**Economic and Social Council**

Economic Commission for Europe**Inland Transport Committee****World Forum for Harmonization of Vehicle Regulations****Working Party on Lighting and Light-Signalling****Seventieth session**

Regulation No. 10 (Electromagnetic compatibility)**Proposal for Supplement 1 to the 05 series of amendments to Regulation No. 10 (Electromagnetic compatibility)****Submitted by the expert from the International Organization of Motor Vehicle Manufacturers***

Appendix 8, figure 2, delete and replace by:

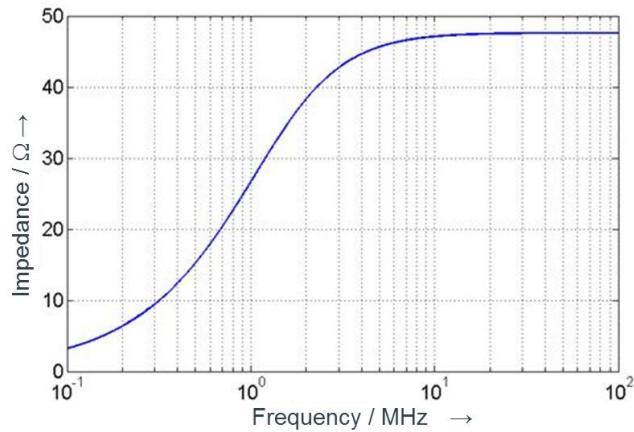
**"Figure 2
Impedance of HV artificial network**

5. Appendix 8: The value of the resistor R_2 shall be increased from 100 k Ω to 1 M Ω because, if the value of this resistor is too low, the isolation protection circuit of a tested high voltage device could be activated and switch off the high voltage system under test. Generally, REESS HV line isolated to the ground or vehicle body by 1M ohm or more to reduce the touch current. R2: 100k ohm in HVAN (High Voltage Artificial Network) will cause some leakage of current from HV lines. A certain level of leakage current will activate the fail-safe function which shut down the HV lines between REESS and HV power module. R2: resistance to the ground earth should apply 1M ohm which is equivalent value to insulation resistance of HV lines of REESS. This HVAN is applied in ESA immunity function test. To confirm the immunity performance in ESA, HVAN should keep the equivalent insulation resistance condition to vehicle test.

6. Appendix 8, figure 2, HV artificial network: editorial correction, from German to English nomenclature.
7. Para. 7.15.2.2.: editorial correction; this clause should refer the ESA Annex.

Annex 9, Appendix 3, figure, to be replaced:

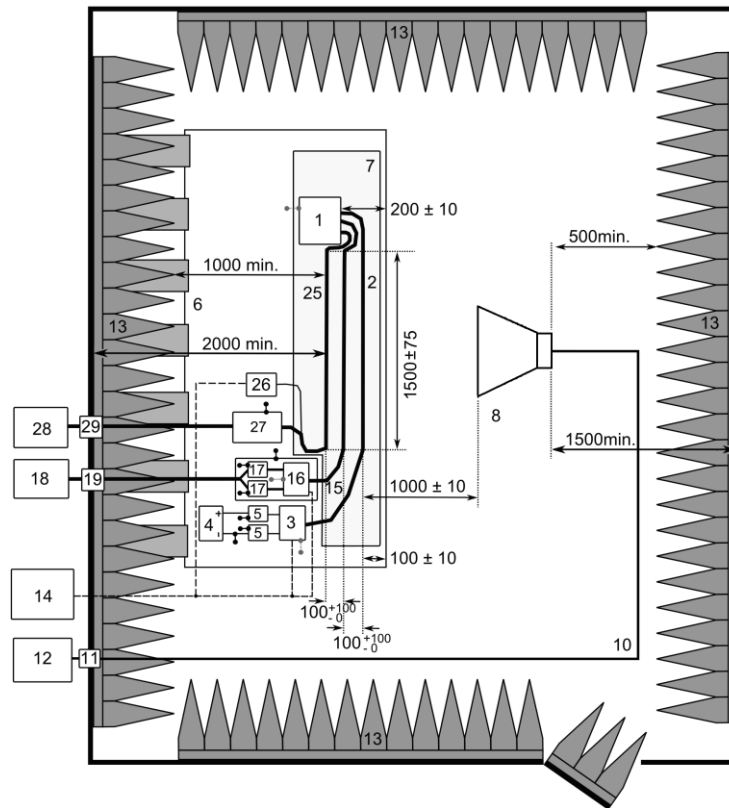
Top view (Vertical polarization)

12. Annex 9, Appendix 3: Figure had to be improved because vertical polarization is applied in this regulation. Vertical layout figure should thus be applied in this annex. In vertical layout figures, a horn antenna figure would be better and easier for recognizing the antenna polarization compared with bi-conical antenna in figures.

Annex 19, Appendix 1, Figure 1, amend to read:

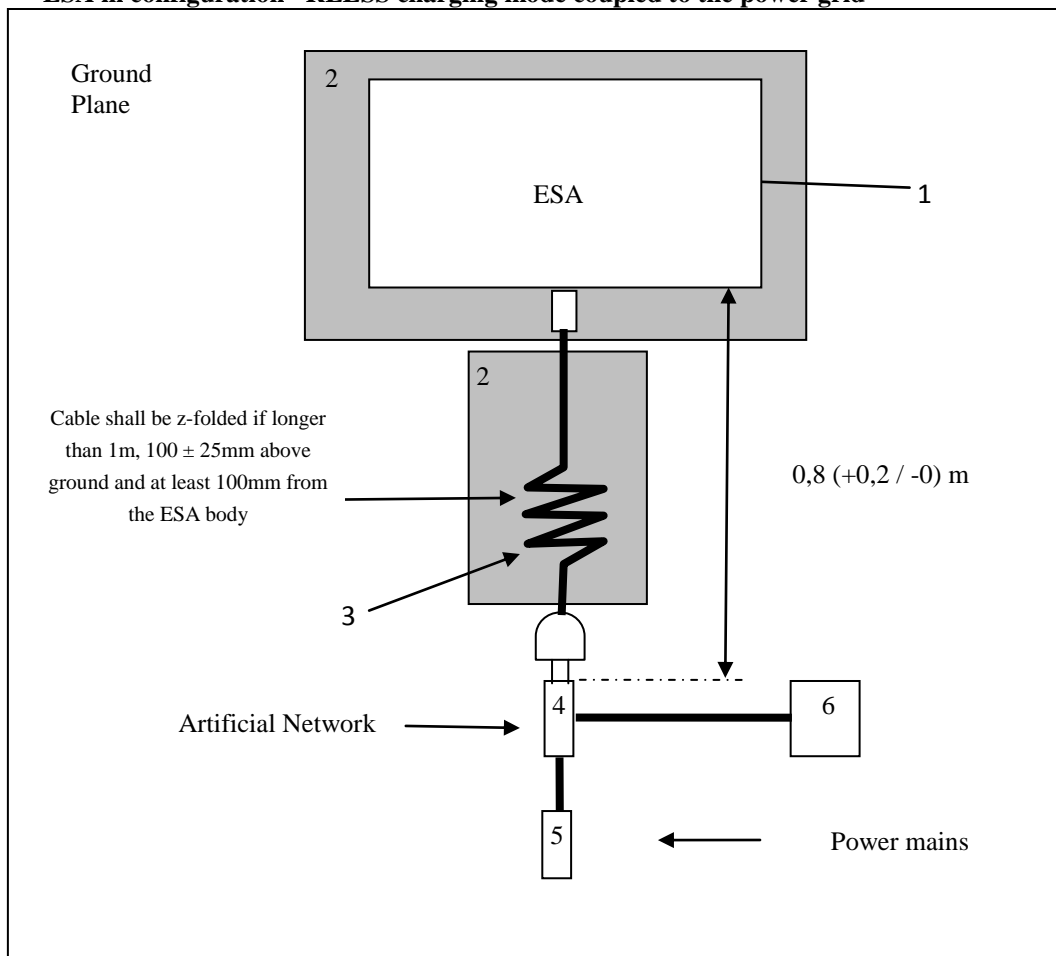
**"Figure 1
ESA in configuration "REESS charging mode coupled to the power grid"**

Figure 1
ESA in configuration "REESS charging mode coupled to the power grid" - Coupling between lines for DC or AC (single phase) power lines.

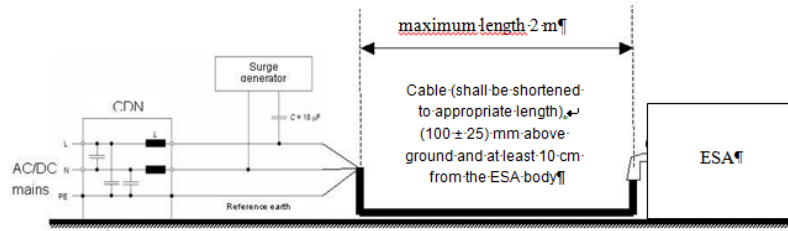
Annex 22, Appendix 1, Figures 1-4, amend to read:
